Village of Bayside
9075 N Regent Road
Architectural Review Committee Meeting
August 17, 2020
Remote Teleconferencing, 6:00pm

ARCHITECTURAL REVIEW COMMITTEE AGENDA

FENCE TYPE

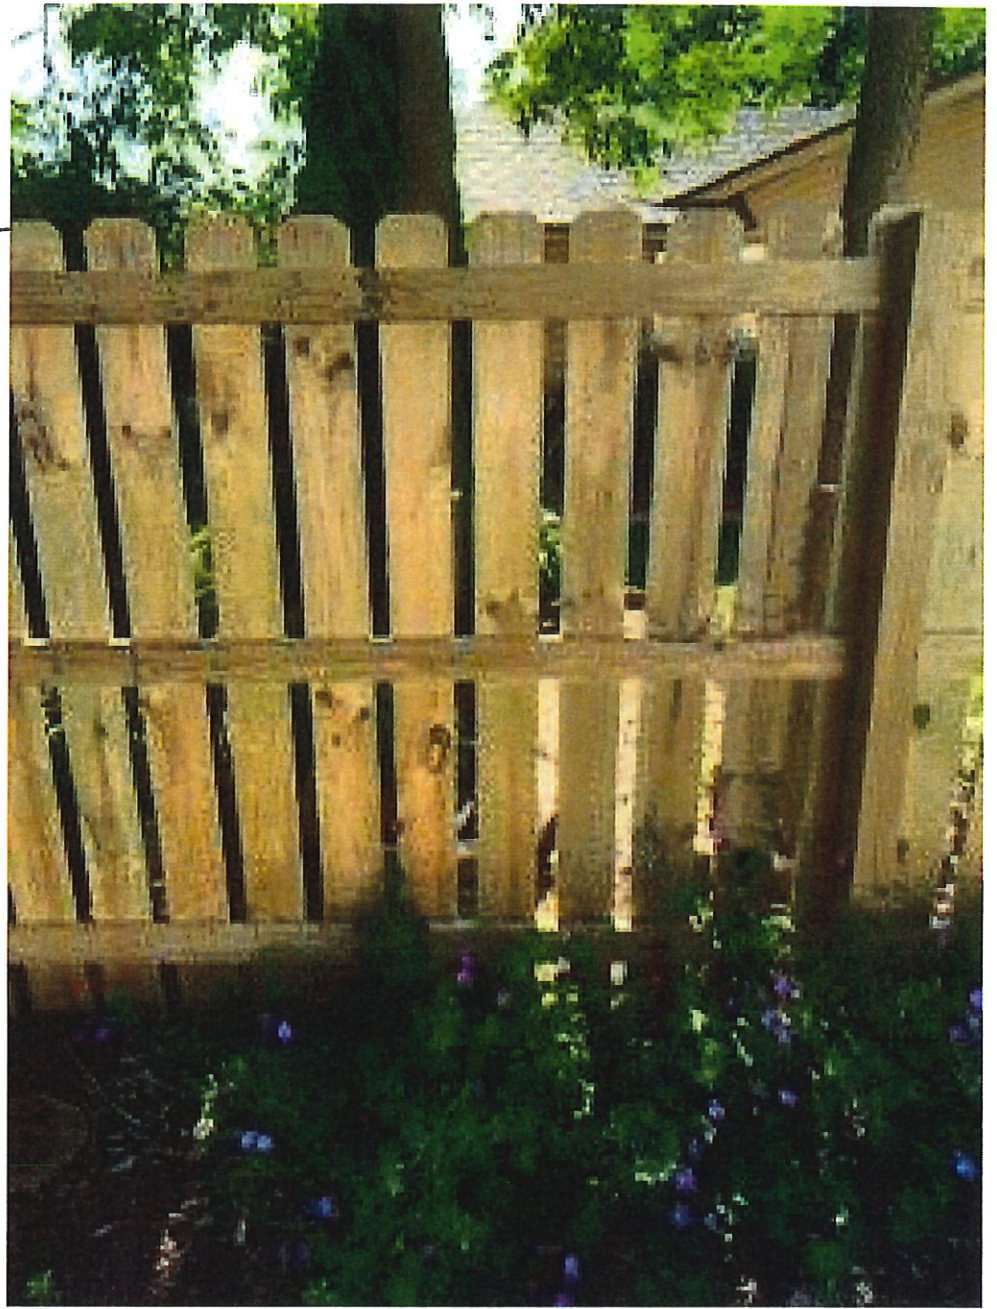
Fence is 25% open and therefore not limited in length.

PROPOSED FENCE TYPE AND LENGTH COMPLY

VILLAGE CODE REVIEW

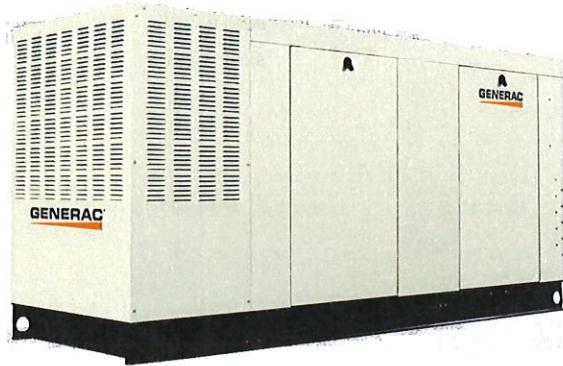
Concrete pad and generator are considered accessory structures and are limited to being located within the rear yard per Village Code Sec 104-4. Section 104-4(f) states:
Except as provided herein, the construction or placement of all accessory structures must comply with the rear and side yard setbacks provided by the zoning ordinances as applicable to structures. All accessory structures shall be located to the rear of the extended rear line of the residence located upon the lot, and with respect to corner residences, shall be located behind the extended rear line and the extended side line adjacent to the street of the residence located on the lot.

Generator installation shall comply with Wisconsin Electrical Code SPS 316, Wisconsin Fuel Gas Code SPS 365 and NFPA 54 National Fuel Gas Code.

Generator location does not comply with zoning code.

VILLAGE CODE REVIEW

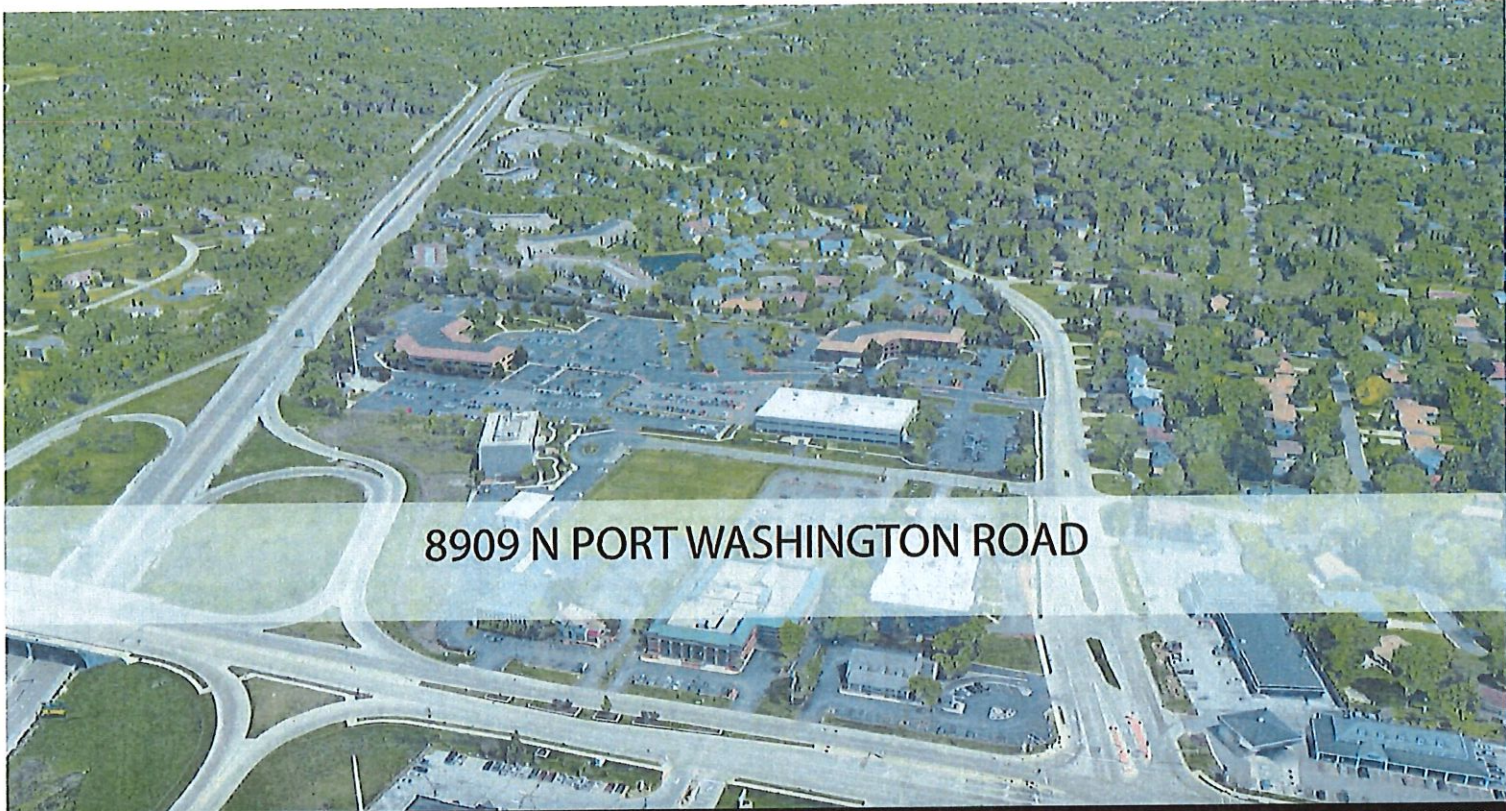
Design proposal includes a new drop off zone, covered by an architectural canopy, which leads to a landscaped entry stair that is adjacent to a vertical architectural element. All these items are additions to the existing commercial building and will be regulated under the Wisconsin Commercial Building Code.

Please note, the new vertical element should not be construed as a commercial building sign as regulated by Bayside Village Municipal Code Section 116-6.

The addition complies with all Bayside zoning setback requirements and 35' maximum height restriction per zoning district D, Municipal Code Section 125-94.

Reviewer believes the exterior improvements proposed for this project significantly improve the existing appearance of the commercial building and provide a more pleasing exterior aesthetic. Reviewer believes this project complies with the following Village Code section:

SAFEbuilt recommends ARC approval.
